SLIM CHICKENS SITE PLAN

PARKER AND PINE FILING NO. 1, LOT 3

TOWN OF PARKER PLAN REVIEW

Blue cloud denotes new comment on this Review 03 dated 4.9.21

SITE PLAN	
SLIM CHICKENS	
COVER SHEET	
SVC OF S. PARKER ROAD AND E. PINE LANE, PARKER, CO 80134	
PROJECT NO:	TSD003.01
DESIGNED BY:	CAM
DRAWN BY:	JLG
DATE:	03/30/2021
C0.0

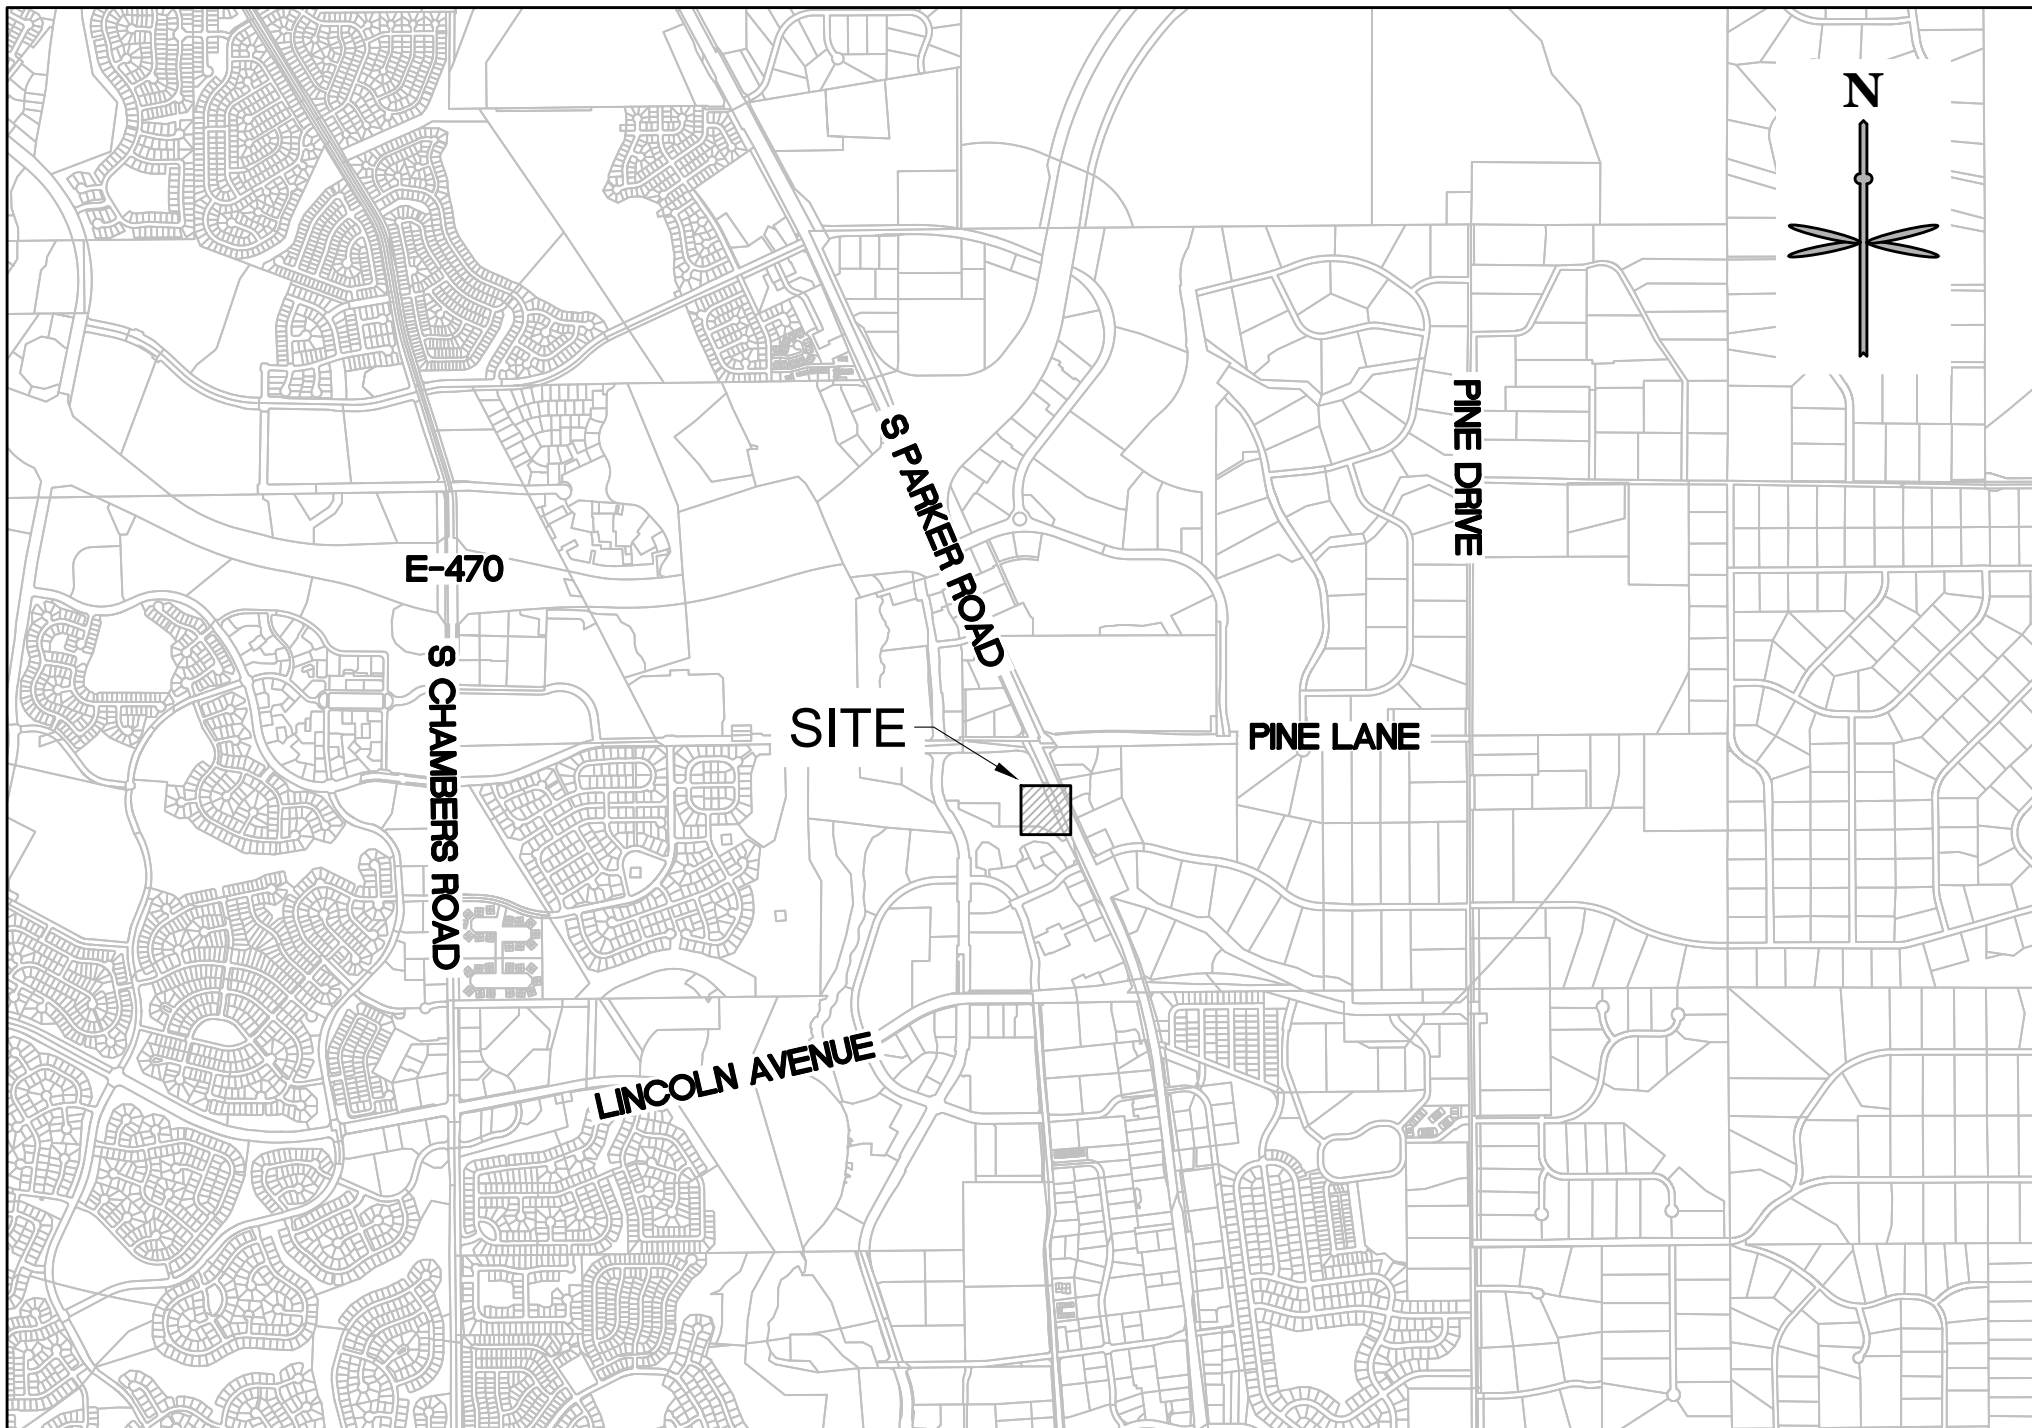
Add Setbacks, Required & Proposed for front/W elev., rear & sides to the table.

C1.0

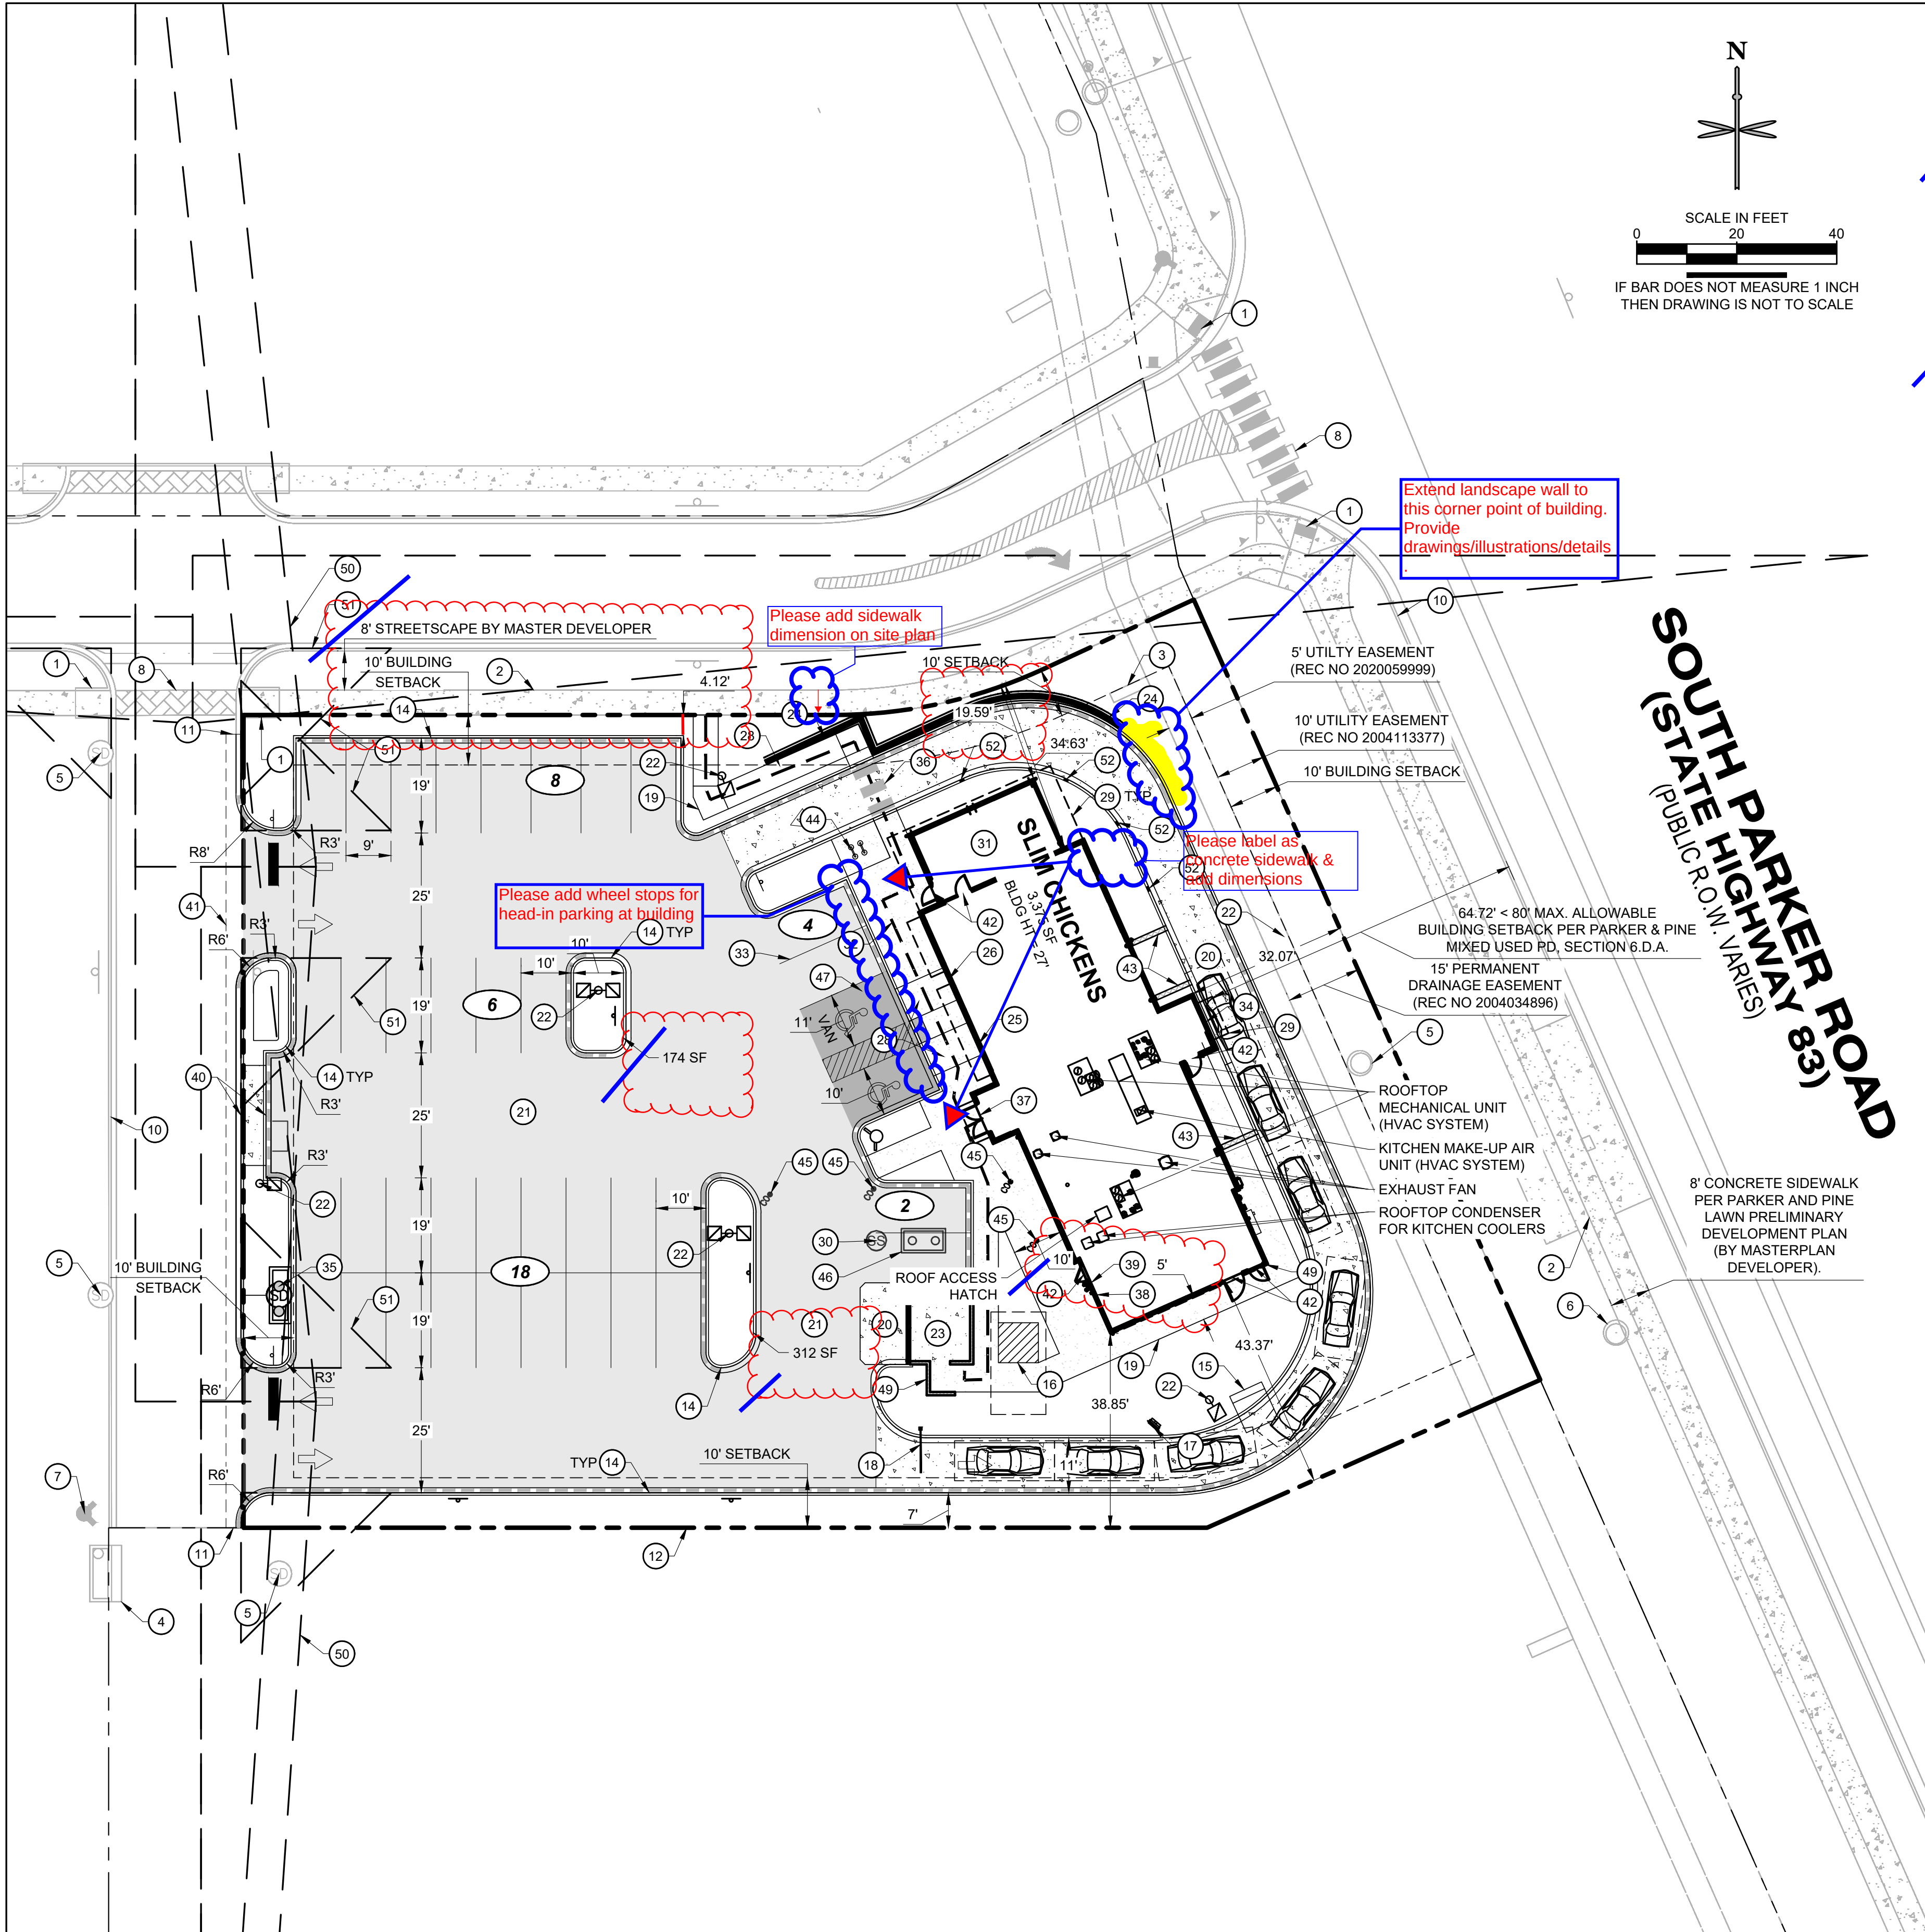
Extend landscape wall to this corner point of building. Provide drawings/illustrations/details

Please add sidewalk dimension on site plan

Please add wheel stops for head-in parking at building

Please label as concrete sidewalk & add dimensions

- PROPOSED DRIVE-THRU MENU BOARD. REFER TO ARCHITECTURAL PLANS UNDER A SEPARATE COVER. **NOT PART OF THIS SITE PLAN APPROVAL. Sign Permit required.**
- PROPOSED DRIVE-THRU CLEARANCE BAR & ENTRY SIGNAGE. REFER TO ARCHITECTURAL PLANS UNDER A SEPARATE COVER. **Entry Signage NOT a part of this site plan approval. Requires separate sign permit.**
